SHINE Medical Technologies, Inc.
SMT-2012-017
Project No. 0792

Subject: Response to Request for Additional Information

Response to Request for Additional Information

Figure 1
The Subcritical Hybrid Intense Neutron Emitter (SHINE)

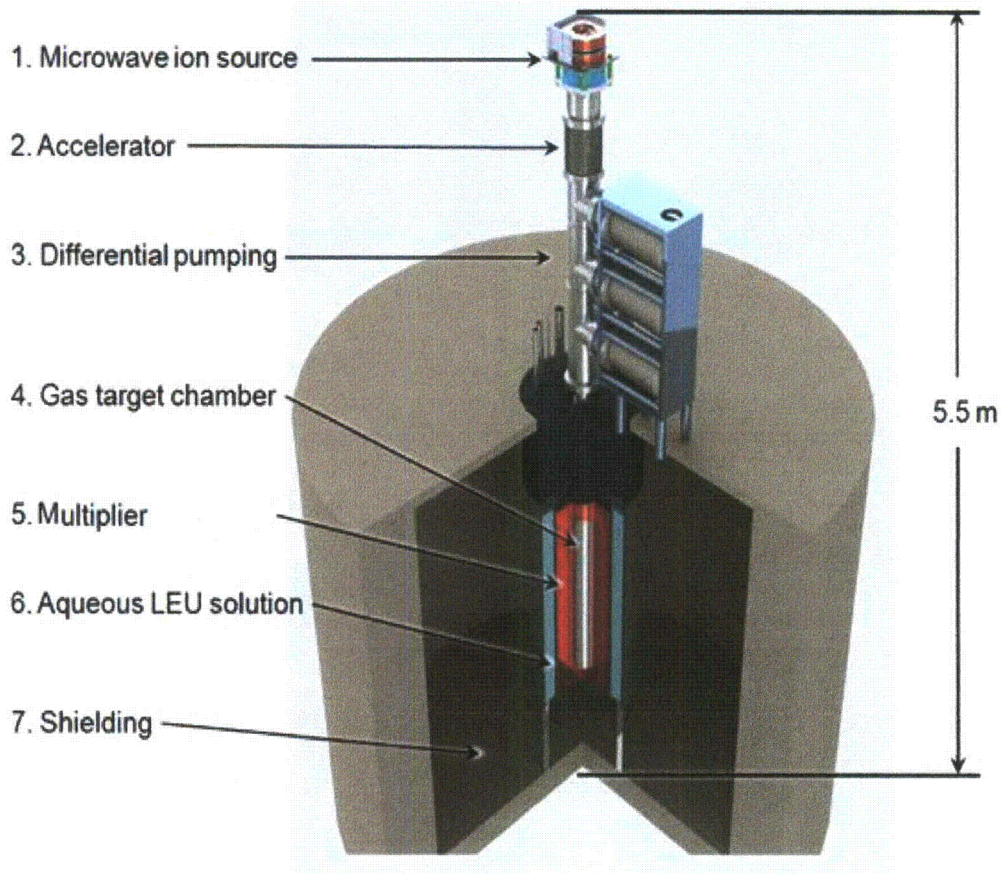
1. A detailed description of the process and equipment which you will be using to make the ^{99}Mo , and that will produce the plutonium. This description should include any information that will allow NRC to determine if your process is a new or novel approach to making plutonium.
2. We would also need accurate projections of the amounts of materials that will be produced in the process. This should include all fission and activation products, including waste stream amounts. How much plutonium and other fission and activation products will be produced per amount of feed material used? How much feed material will be used per batch and per year?

1. At the top of the device (see **Figure 1**), an ion source provides a deuterium ion beam and collimates it to approximately 1 cm^2 .
2. The beam is accelerated by an electrostatic accelerator.

3. The beam passes through the differential pumping sections which serve to keep the accelerator at its working pressure, while maintaining sufficient target gas pressure to produce high neutron yield.

4. The gas target chamber is filled with tritium gas. When the accelerated deuterium ions enter the target chamber, they impact the tritium gas, resulting in nuclear reactions which create neutrons.

5. The neutrons enter a multiplier layer which increases the source neutron population by 2-3 times before entering the target solution vessel (TSV)
6. After multiplication, the neutrons enter the Low Enriched Uranium (LEU) target solution vessel causing ^{235}U therein to fission, creating more neutrons and fission products, including ^{99}Mo . ^{99}Mo accumulates in the solution during the irradiation cycle. The TSV is operated as a subcritical process ($k_{\text{eff}} < 1.00$) at all times.

7. The LEU target vessel is surrounded by a light water pool which reflects neutrons back into the solution vessel, cools the system, and absorbs radiation produced by the device.

8. After several days of irradiation, the solution is removed from the LEU target vessel and ^{99}Mo is separated, purified, tested, and packaged for shipment to $^{99\text{m}}\text{Tc}$ generator manufacturers.
9. The LEU target solution is returned to the TSV for another irradiation.
